Access Compliance Report

Public Rights-of-Way

Intersection ID: 8895	Main Street: BINGHAM_DR	Cross Street: N_TRYON_ST	Location: SW
ADA ID: B8C3F38C4054	Ramp Type: Perp	Initial Pass/Fail: Fail	Overall Compliance: No
		Severity Score: 1.25

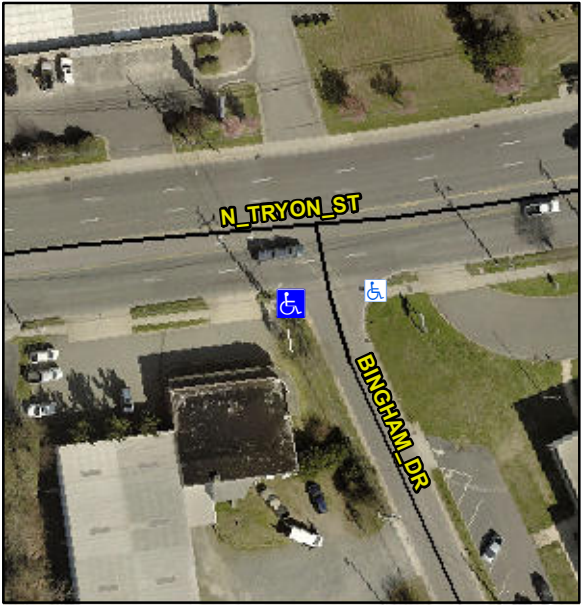
Codes/Mitigation Info/Possible Solution			Field Measurements/Component Compliance		
	Possible Solutions:		Compliance	Description	Data
	Remove & Replace Entire Ramp.		Yes	Ramp Length (in)	25.5
			No	Ramp Width (in)	48.0
			N/A	Flare Type LT	N/A
			N/A	Flare Slope LT (%)	N/A
			N/A	Flare Traversable LT?	N/A
			N/A	Landing Length (in)	N/A
			N/A	Landing Width (in)	N/A
			N/A	Landing Slope (%)	N/A
			N/A	Landing X Slope (%)	N/A
<p>Surveyor Notes:</p> <p>N/A</p> <p>PROW/ADA:</p> <p>Not Found, R304.5.3</p>			N/A	Flare Type RT	N/A
			N/A	Flare Slope RT (%)	N/A
			N/A	Flare Traversable RT?	N/A
			N/A	DWS Provided?	N/A
			N/A	DWS Contrast?	N/A
			N/A	DWS Length (in)	N/A
			N/A	DWS Full Width?	N/A
			N/A	DWS Offset (in)	N/A
			N/A	Gutter Ponding?	N/A
			N/A	Gutter Lip Ht (in)	N/A
			No	Painted X Walk1?	N/A
				X Walk 1 Direction	To E
			N/A	X Walk 1 Width (in)	N/A
				X Walk 1 Slope (%)	2.7
				X Walk 1 X Slope (%)	4.6
			N/A	Ramp inside XWalk1?	N/A

N/A	Road Slope (%)	N/A
			N/A	Road X Slope (%)	N/A
			N/A	Any Obstructions?	N/A
				Obstruction Type	
Total Cost: \$ 1850.00			N/A	Storm Grate/Utility Hazard?	N/A
			N/A	Storm Grate/Utility Type	N/A
			Yes	Surface Condition? (G/P)	Good
